Models 120, 125, 132

New clutch

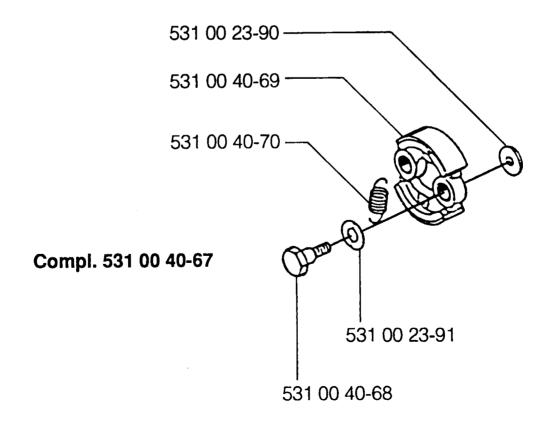
In order to meet the demand from the professional users there is now a clutch available, which is more rigid and with longer life.

Besides clutch shoes also the clutch spring and the screw should be changed to new ones with reinforced design.
